MEMORANDUM

SUBJECT: EPA Alternative Post-Injection Site Care (PISC) Review Memorandum for the Marquis Class VI permit– Permit Number IL-115-6A-0001; Putnam County, IL

Summary

Figure 9-3: Cross-sections of the carbon dioxide plume extent at the end of the 6-year injection period (9.0 Post-Injection Site Closure Plan (February 2025), A.R. #1535).

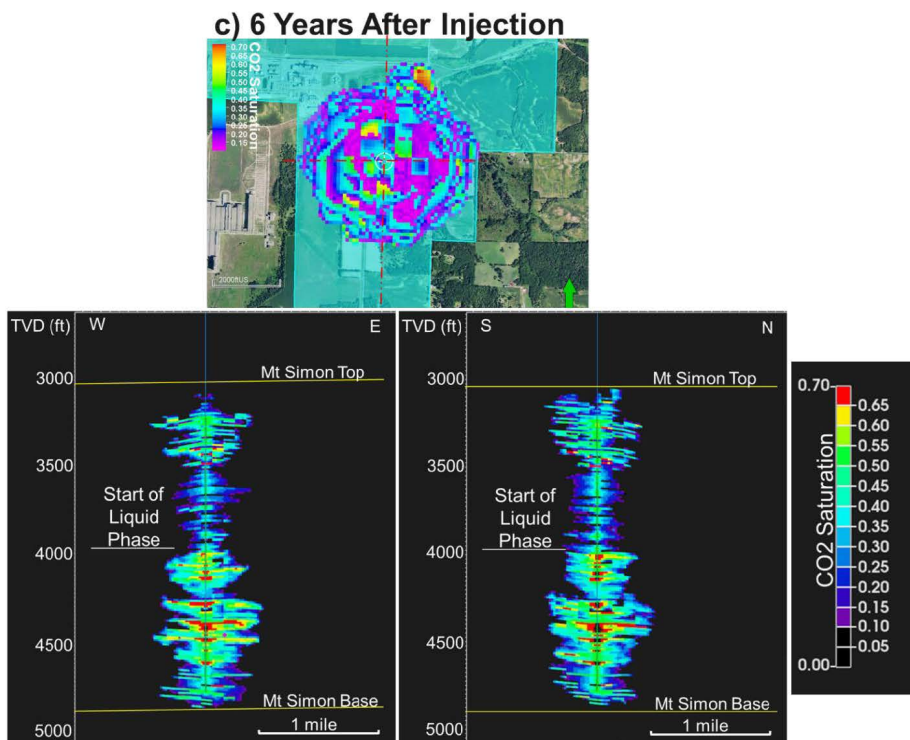
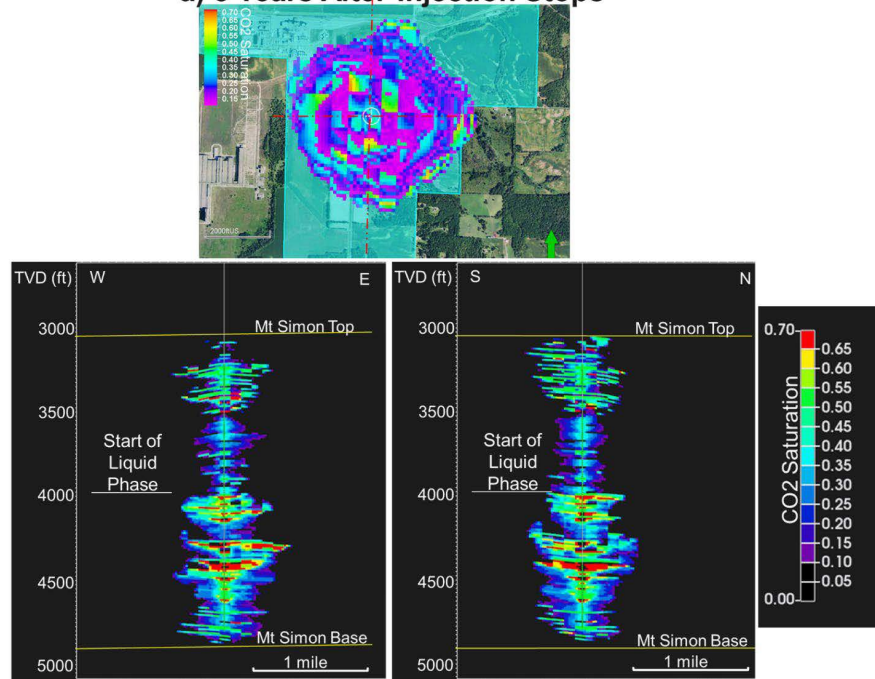
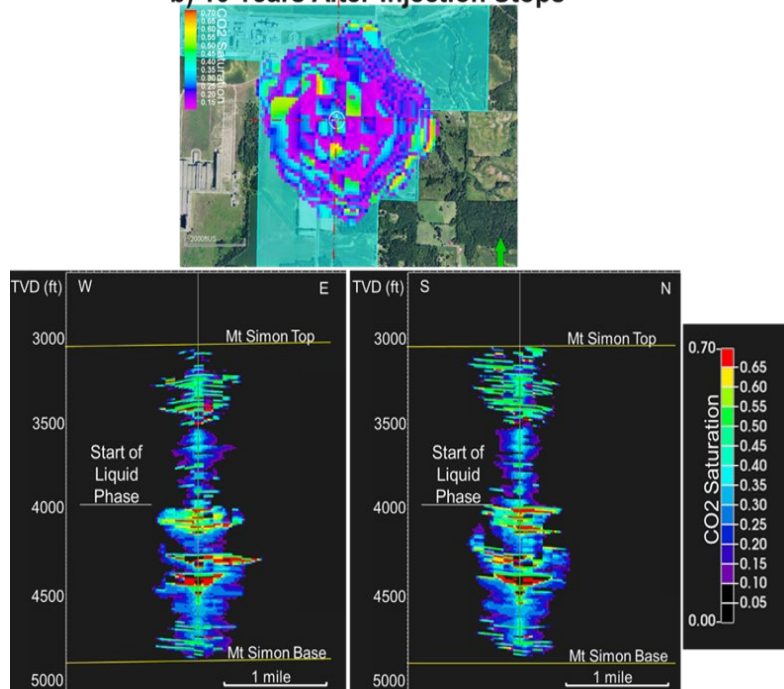
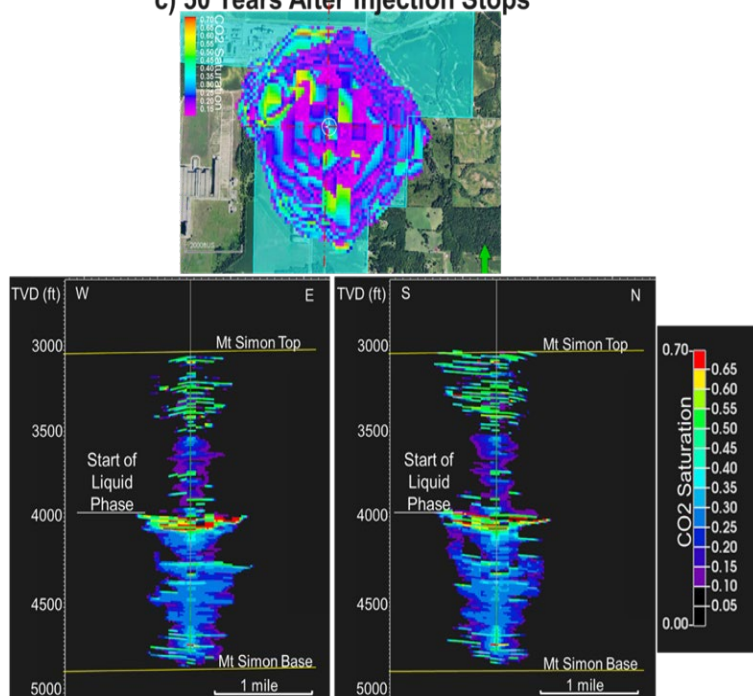
The model showed that the expansion of the plume will plateau by the end of the alternative-PISC timeframe. Furthermore, the AoR was delineated using the pressure front, as the pressure front is larger than the plume extent under all scenarios. EPA has verified that the computational modeling performed demonstrates that the injectate will stabilize and injection zone pressures will decrease soon after injection ends. The model included trapping rates that supported the plume migration results (Section 9.0 PISC and Site Closure Plan (August 2024) A.R. #1542). EPA agrees with the model's inputs, outputs, variables, and assumptions.

Figure 9-1(a): Pressure at Well Block/Cell Including Initial Time Step for the 6-year injection phase and a post injection period of 50 years (A.R. #1535).

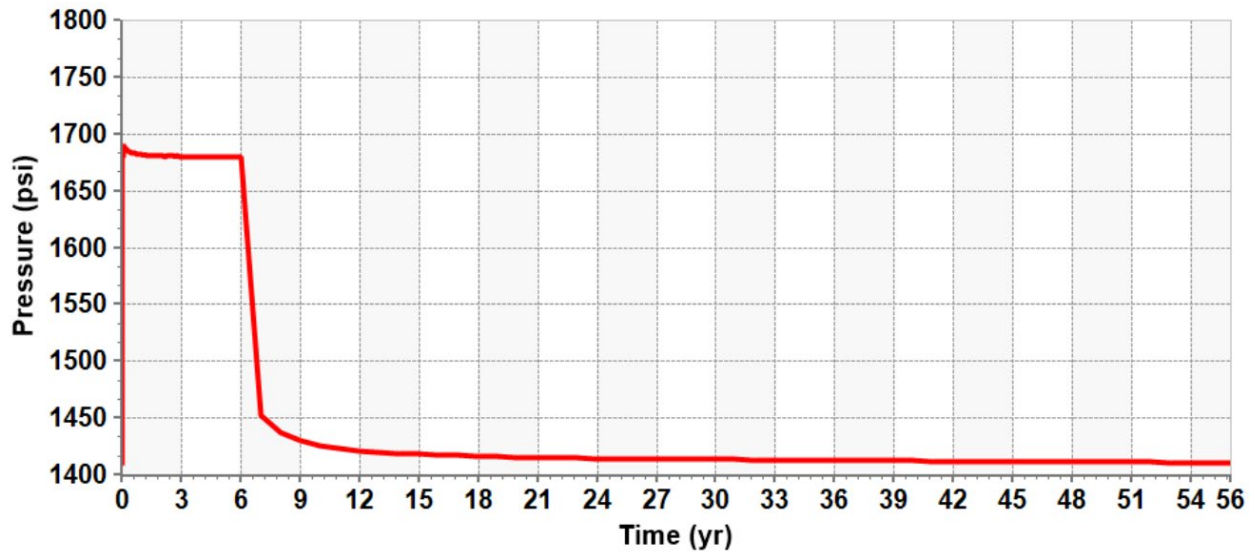
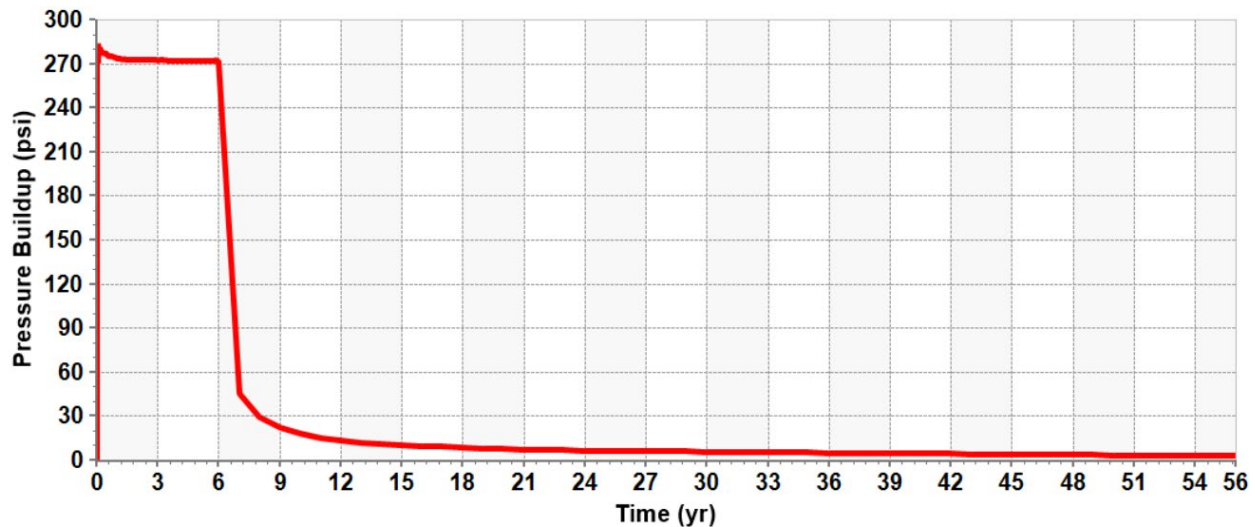
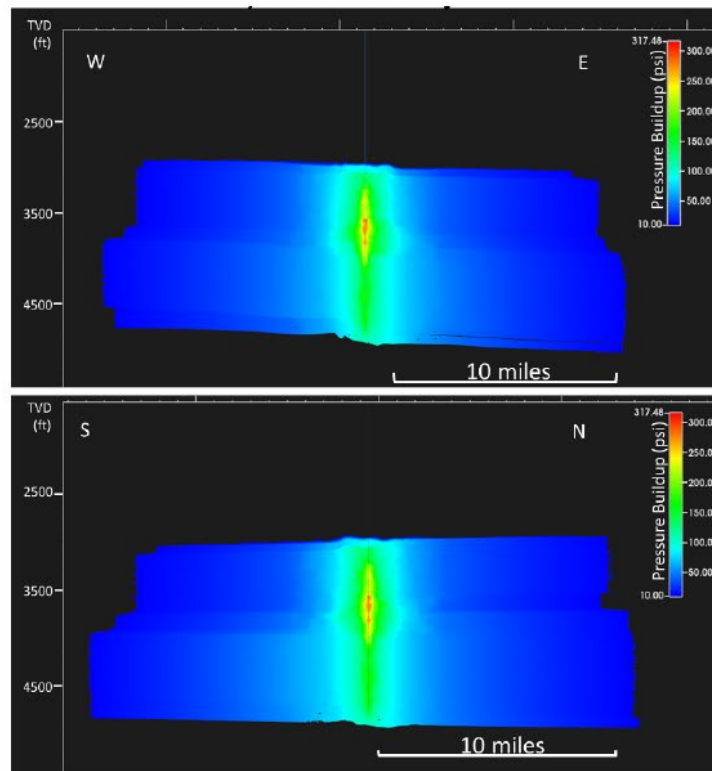
Although the pressure front is largest at the end of injection, the pressure increase within the injection zone will peak immediately after injection begins before declining slightly. However, the injection zone pressure will remain largely stagnant – as well as staying below 90% of the formation fracture pressure – during operation. Based on the model, the areal extent of the pressure front and the pressure differential in the injection zone shrink rapidly after the 6-year injection period. 12 years after injection ceases, modeling predicts the pressure in the injection zone will decrease to pre-injection levels. That is, the pressure differential is expected to be less than 1% (9.0 Post-Injection Site Closure Plan (February 2025) A.R. #1535 at Figures 9-1(a) and 9-1(b)). Since there is naturally existing pressure within the injection zone, a pressure differential less than 1% is not directly attributable to the injection pressure front.

After considering 40 C.F.R. § 146.84, EPA agrees with the model's inputs, outputs, variables, and assumptions, and the results of the model are valid using the site-specific data. The pressure decline has been accurately defined. Marquis has demonstrated that formation fluids will not be forced into USDWs due to the elevated pressure.

Figure 9-5: Predicted pressure plume development /dissipation at years 1, 5, and 10 post injection (A.R. #1535).

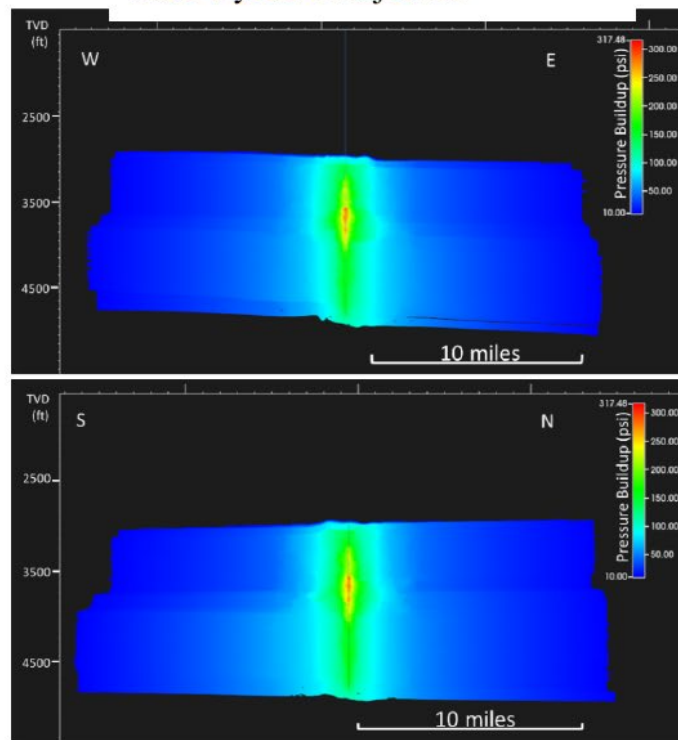
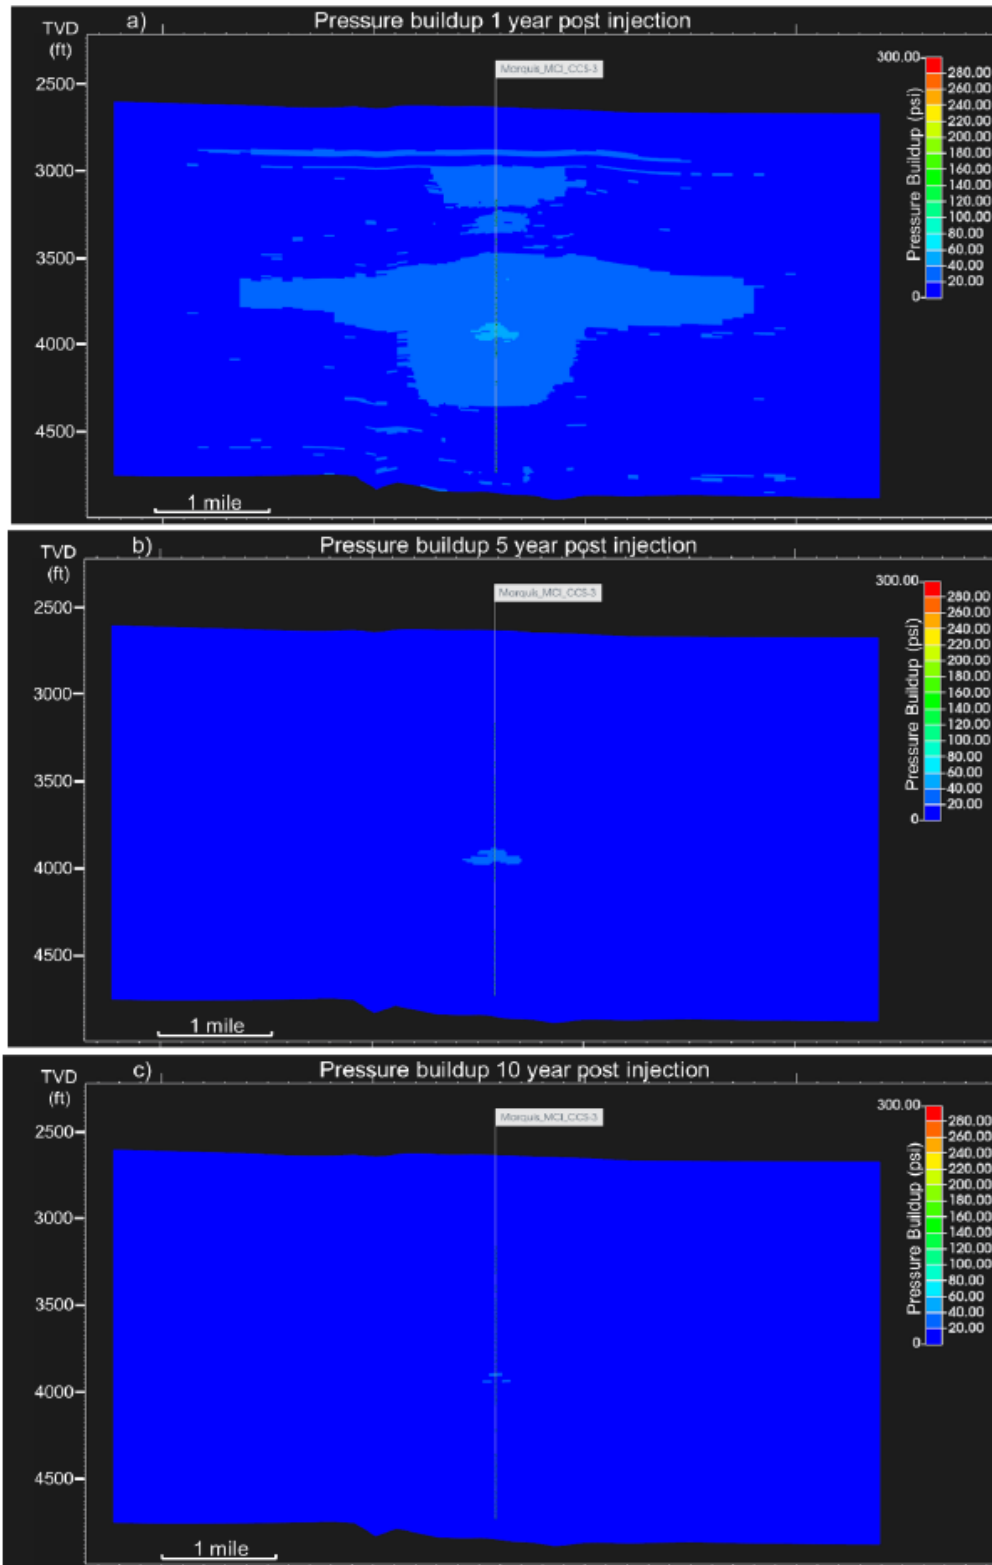
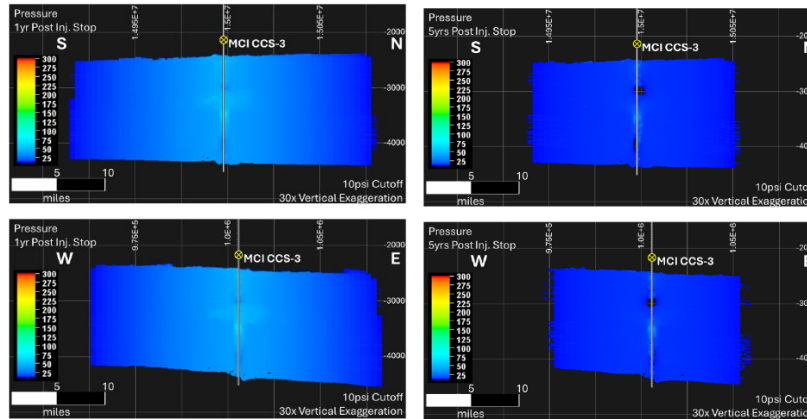
Marquis also provided figures showing the modeled evolution and maximum extent of the pressure front, accounting for trapping over the life of the project. Specifically, at years 4 and 6 of injection, and years 1, 5, and 10 after injection ends (A.R. #1535 at Figures 9-4 and 9-5). As seen in Figure 9-5, the pressure front will almost entirely disappear 10 years after injection stops. The Alt-PISC Timeframe for Marquis is 12 years, meaning the pressure front at the time of site closure will be even smaller than as shown in the figure. Figures 2-101, 2-101(b), 2-101(c), 2-103 and 2-104 also demonstrate the same information. (A.R. #964).

Figure 2-32: Hydrogeologic velocity of the carbon dioxide plume following injection (A.R. #964).

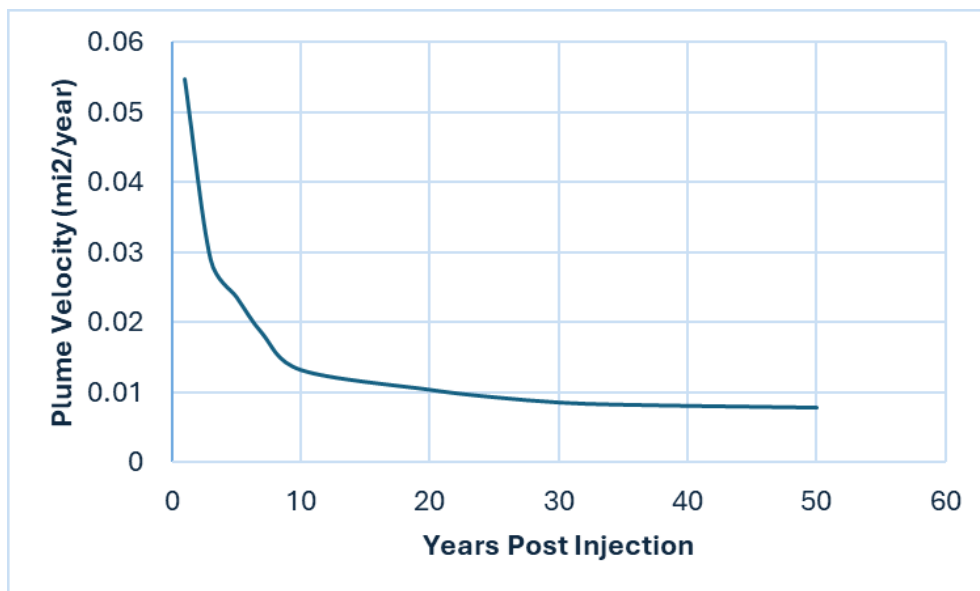
The CO₂ plume as predicted by the model is largely static at 12 years post-injection and beyond (A.R. #1535 at Figures 9-3, 9-3(a), 9-3(b), and 9-3(c)). Specifically, at the end of the proposed PISC timeframe, the rate of plume expansion is minimal: 0.01 mi²/yr. After injection ends, a decrease in injection zone pressure and increase in CO₂ trapping slow plume expansion (A.R. #964 at Figure 2-32).

Variation in injection zone porosity and permeability could affect CO₂ migration. However, the sensitivity analyses discussed above account for this uncertainty. Under all sensitivity cases, plume growth declines quickly following the end of injection, and the injectate remains trapped by the confining zone. All the model iterations also demonstrate that the plume extent will be very small compared to the AoR. The large buffer between the edge of the plume and the edge of the AoR provided further justification that the entirety of the plume will be properly monitored. Therefore, based upon EPA's review, the model was correctly run to depict the rate of CO₂ plume migration over time.

Figure 9-9: CO₂ dissolved in brine, CO₂ residually trapped in brine during injection, and free CO₂ as a percentage of total CO₂ moles injected during the injection and post-injection periods (A.R. #1535).

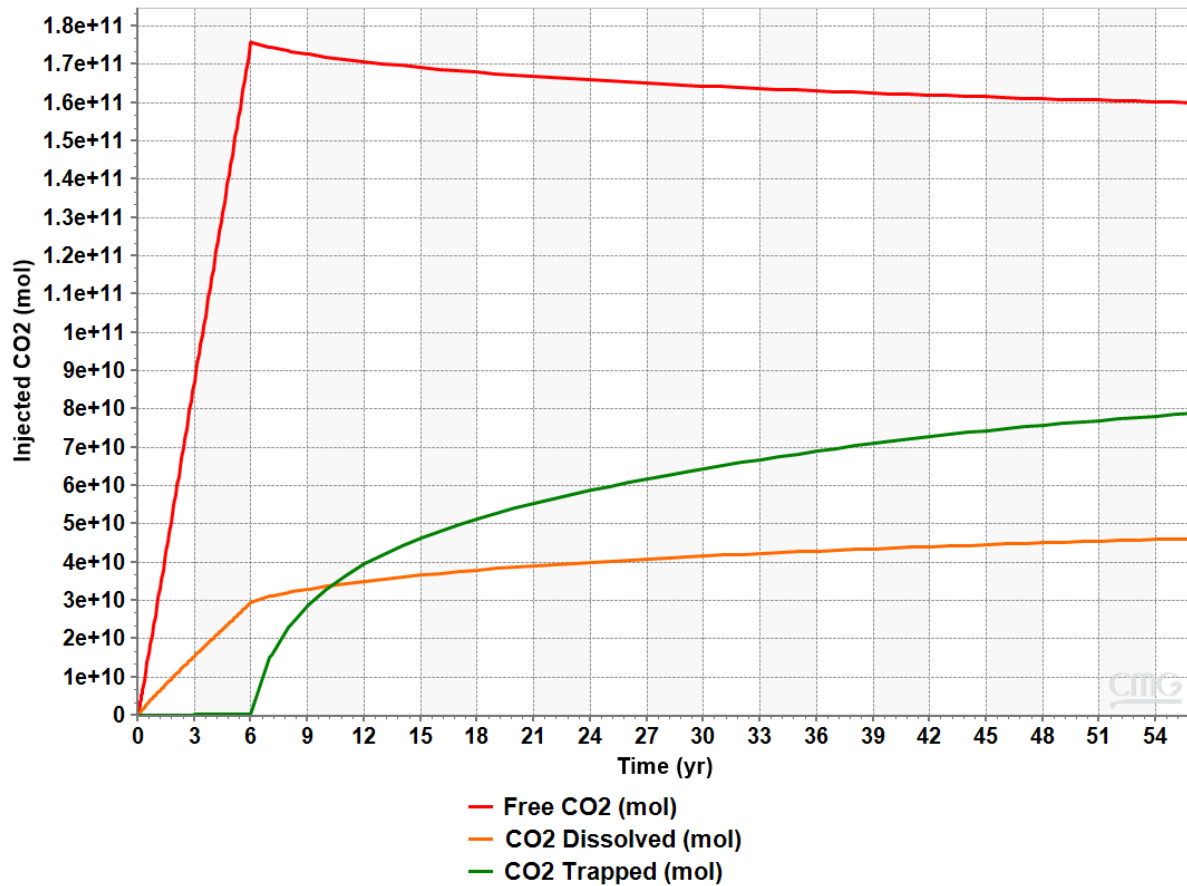
Marquis’ alternative PISC timeframe demonstration included predicted rates of CO₂ trapping in the immobile capillary phase and dissolved phase. Per EPA’s review, Figure 9-9 demonstrates carbon dioxide will be trapped, and migration of carbon dioxide will slow over time at various rates dependent on the type of trapping processes (9.0 Post-Injection Site Closure Plan, A.R. #1542 at Figure 9-9 and A.R. #964 at Figure 2-40). The full site-specific model (with geologic heterogeneities included) was run by incorporating solubility and residual trapping modules during injection and post-injection conditions to predict/estimate (1) the total CO₂ in the system, (2) CO₂ dissolved in brine (i.e. dissolved phase), (3) CO₂ residually trapped in brine during injection (i.e. immobile capillary phase), and (4) structurally trapped CO₂ as a percentage of total CO₂ moles. This is illustrated in Figure 9-9 below, which was pulled from A.R. #1535. Marquis modeled trapping for 56 years, 6 years of injection and 50 years post-injection to facilitate comparison between a standard and an alternative PISC timeframe. (Note: In Figures 9-9 and 2-40, large amounts of injected CO₂ are labeled as “free.” This means that the CO₂ is not geochemically trapped. However, it is still physically trapped by the confining zone.) Specifically, by year 12 post-injection 9×10^{10} moles of CO₂ will be immobilized (5×10^{10} due to

These predicted rates of trapping at year 12 post-injection show sufficient decline in the migration of the CO₂ plume that when considered alongside the decline in the pressure front demonstrate non-endangerment of USDWs.

Figure 2-40: Ratios of free, dissolved, and trapped CO₂ to total CO₂ injected during and post injection (A.R. #964 at Figure 2-40).

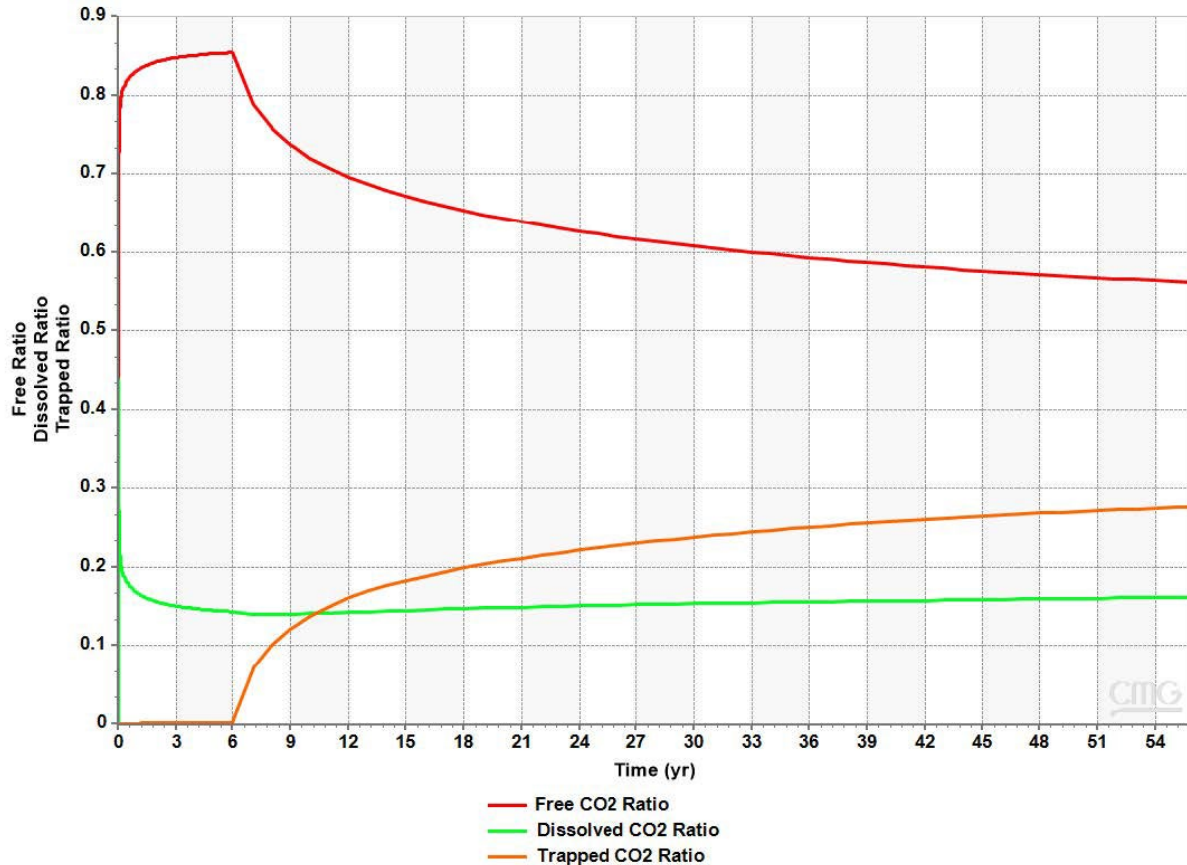
thickness and permeability variations of the Mt. Simon Sandstone, significant amounts of CO₂ can be residually trapped. Residual CO₂ trapping increases during the post-injection time period. Per Figure 2-40, 20% of the injected CO₂ will be residually trapped at year 18 (6-years of injection and 12-years post injection). (A.R. #964).

The geochemical trapping process introduces the dissolved phase (also known as dissolution or solubility trapping), which is demonstrated by the Marquis' use of Henry's solubility model. This model uses a constant determined by pressure, temperature, and salinity as published by Harvey (1996).¹¹ The model calculates the fugacity/partition coefficients for soluble CO₂ in aqueous phase using Li & Nghiem (1986) method.¹² Per Figure 2-40, 15% of the injected CO₂ will be trapped via dissolution at the end of the alt-PISC timeframe (year 18). (A.R. #964).
